**Addendum No. 001**

**Subject: 2020 Classroom Modernizations**  
**SDP Contract Numbers: B-028 C of 19/20 & B-030 C of 19/20**

**Location: Overbrook Educational Center**  
**6722 Lansdowne Ave, Philadelphia PA 19151**

**This Addendum, dated March 6, 2020, shall modify and become part of the Contract Documents for the work of this project. Any items not mentioned herein, or affected by, shall be performed strictly in accordance with the original documents.**

1 PLUMBING THIRD FLOOR NEW WORK PLAN  
MP1.3 1/8" = 1'-0" 0 4' 8' 16'

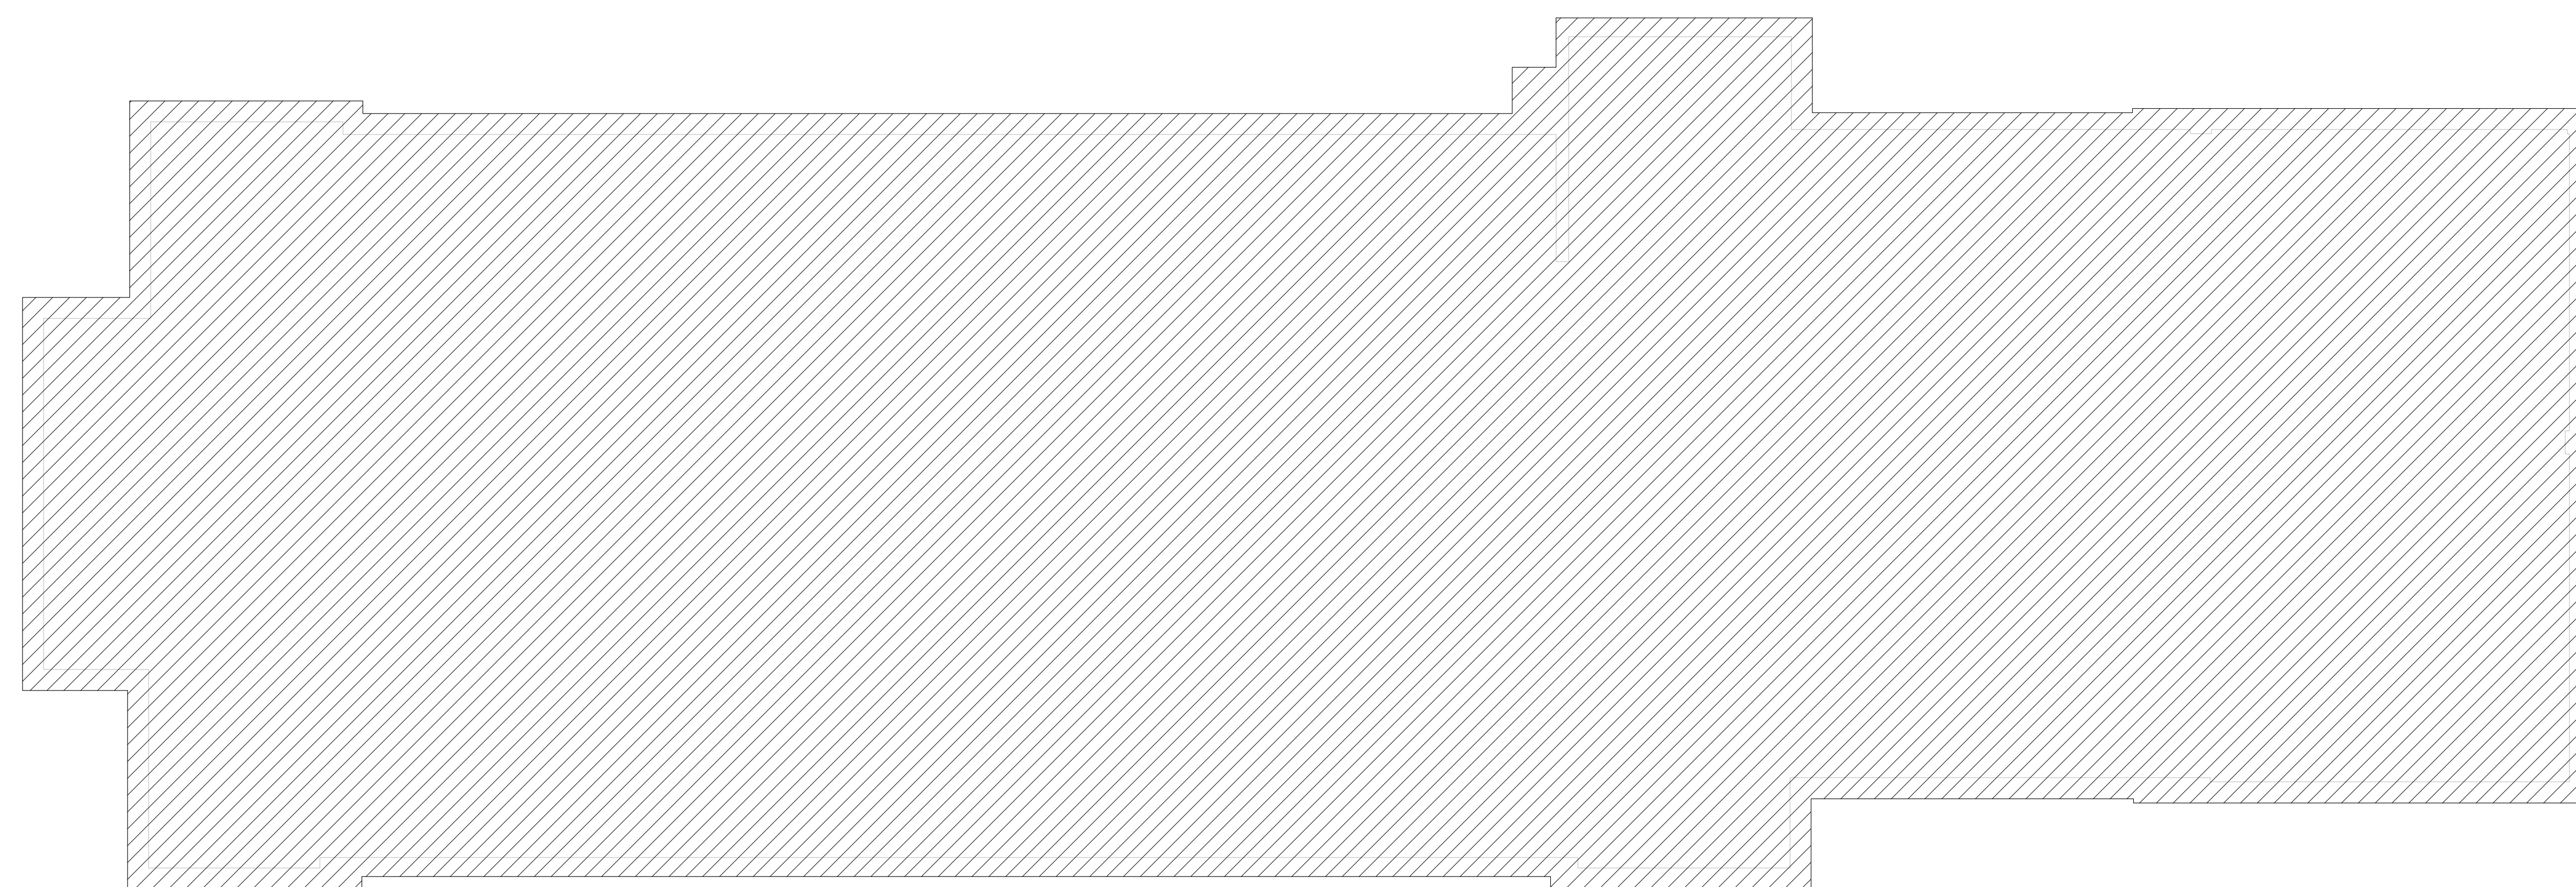
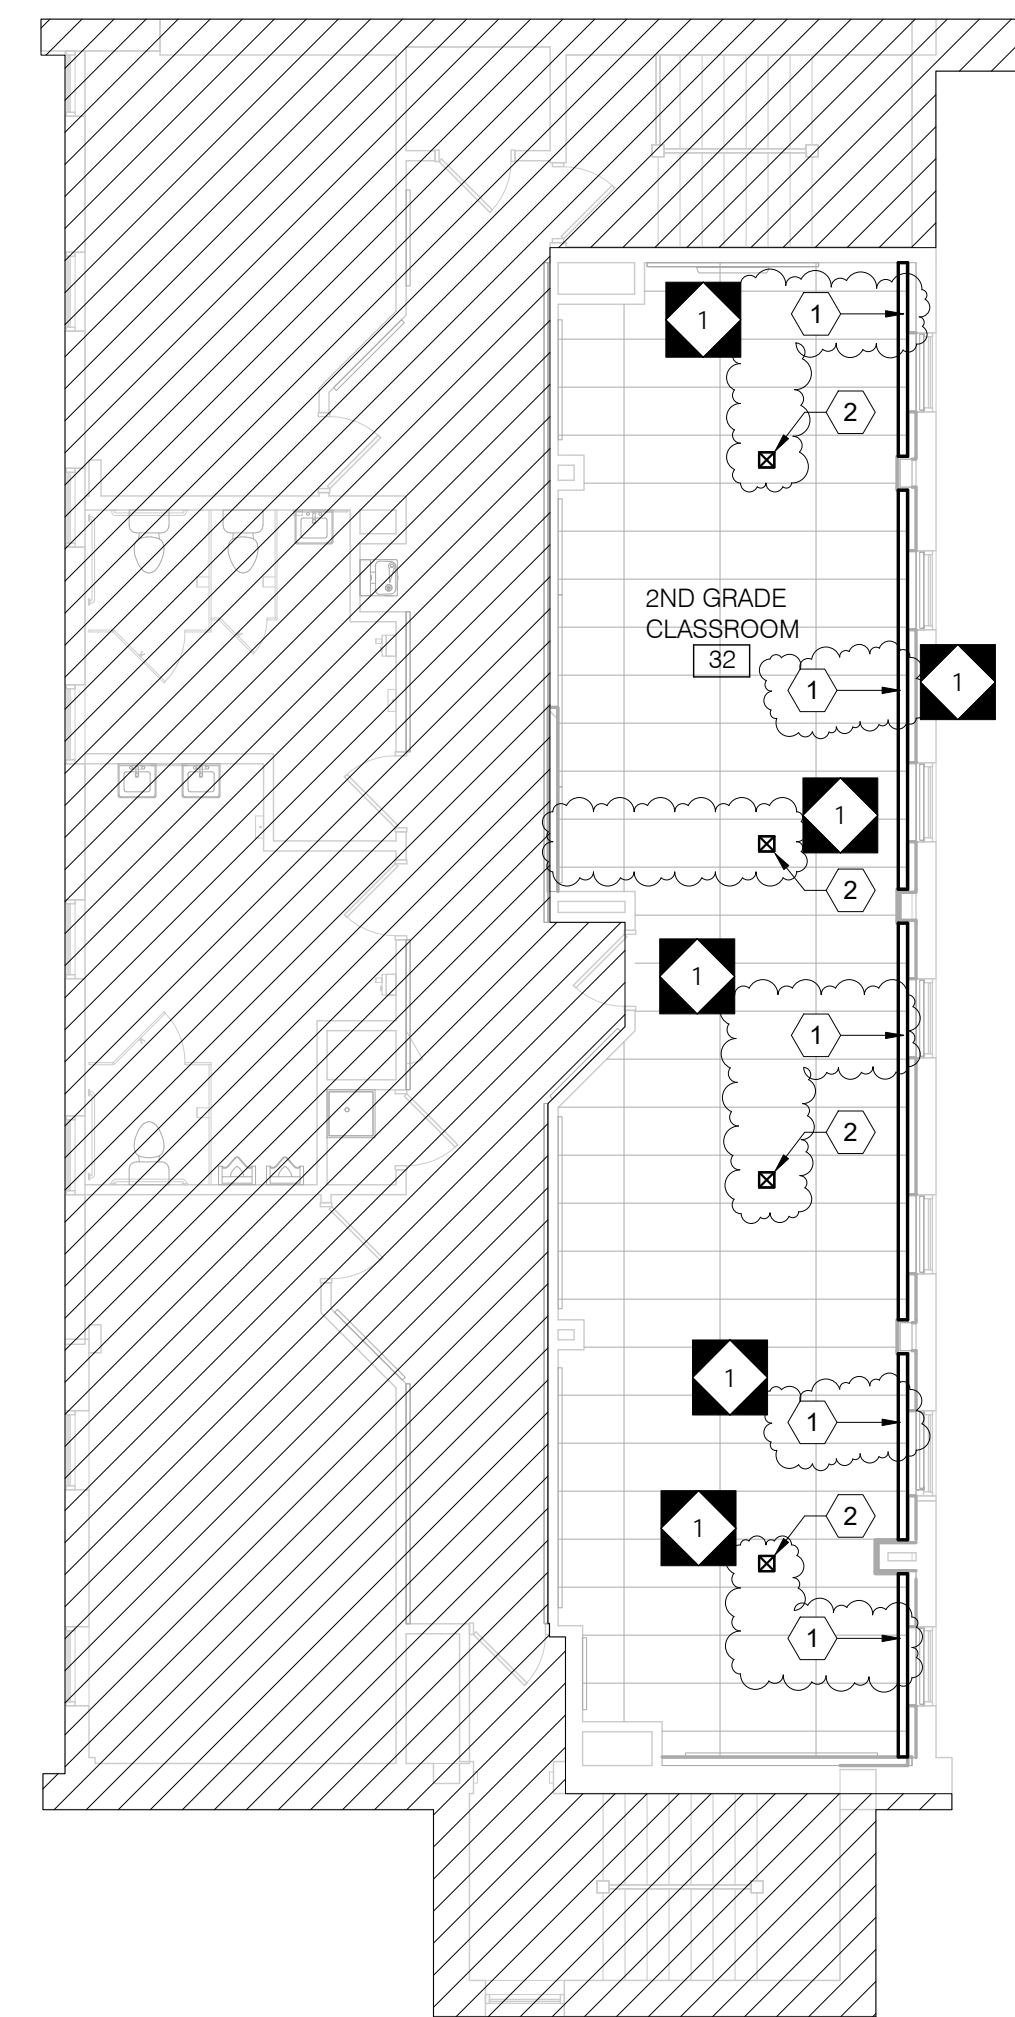
1. REVISE sheet number.
2. ADD Sheet Key Notes as indicated on the drawings.
3. REVISE scope as indicated on the drawings.
